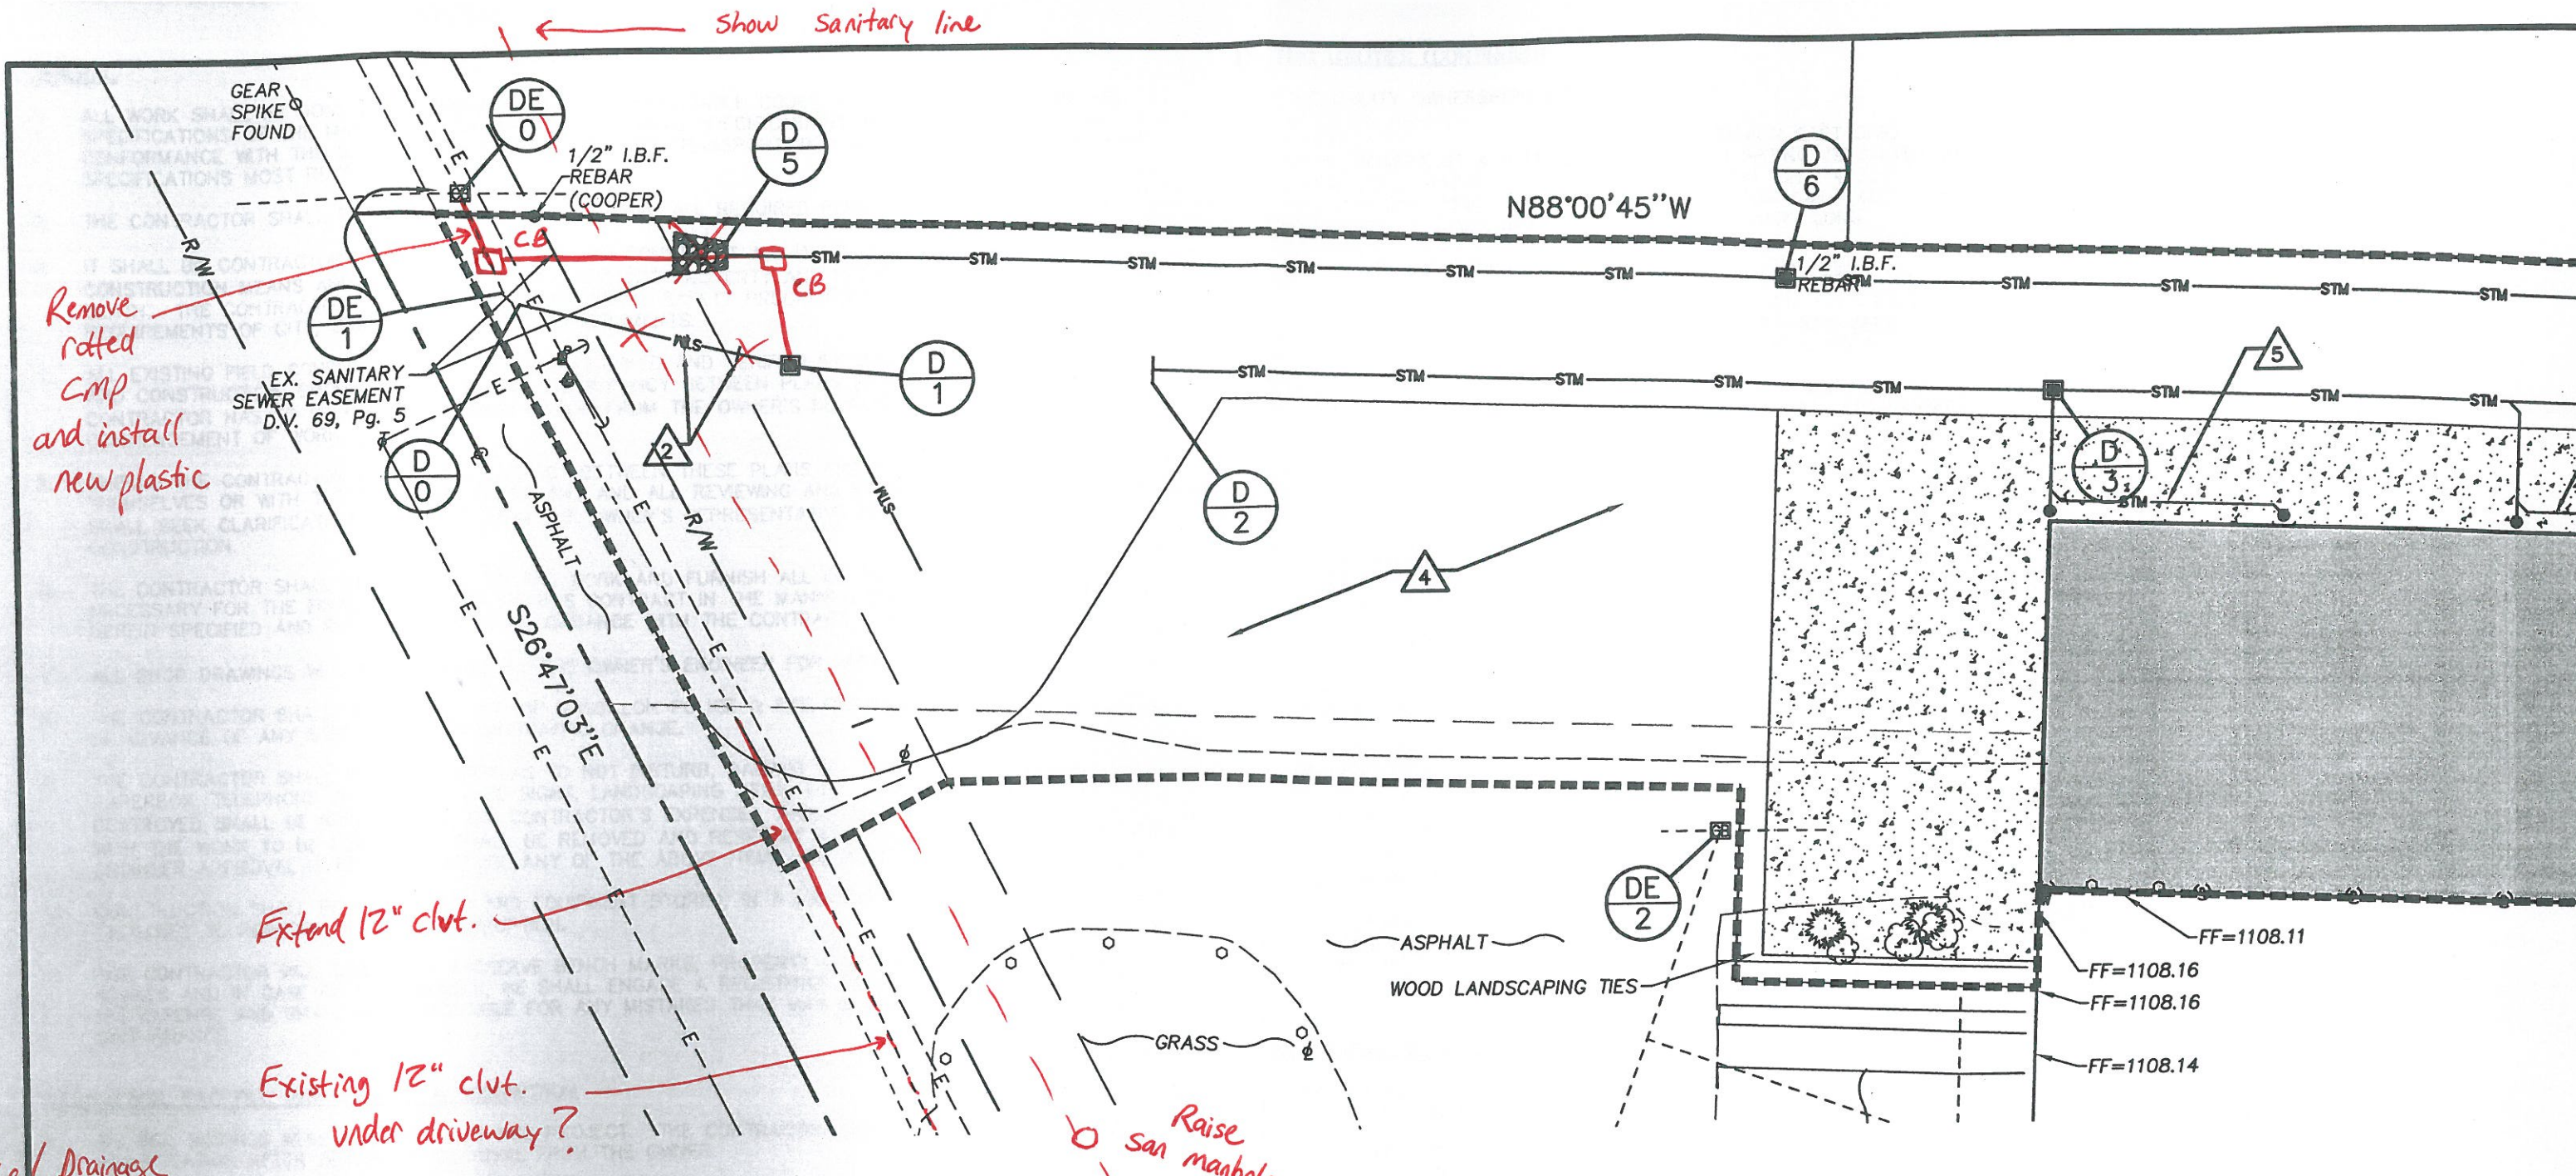
Label Drainage pipes on the plans!
